BULLETIN #166

MARCH 18 2003

RELEASE OF P01500 CONTROL VALVES IN MODELS P-80 AND P-80A

Old Combination New Combination

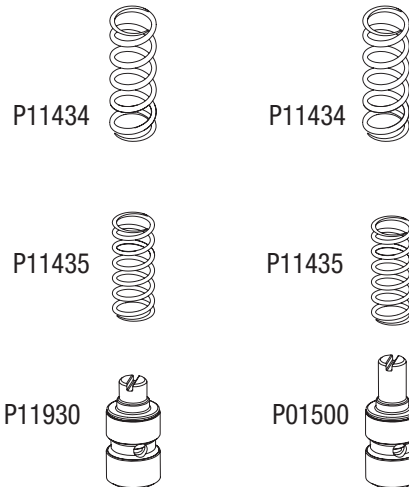
Pacbrake has released the use of P01500 control valves in all P-80 and P-80A engine brakes.

The control valve part number P01500 replaces the previously used part number P11930.

The P01500 control valve will be used with inner control valve spring part number P11435 and outer spring part number P11434. If updating an engine brake to a new combination, it is imperative all cylinders are done. It is not recommended to interchange the new and old combinations in the same engine brake.

P-80 engine brakes Serial #091788 and later contain the new control valve.

P-80A engine brakes Serial #098259 and later will contain the new control valve.
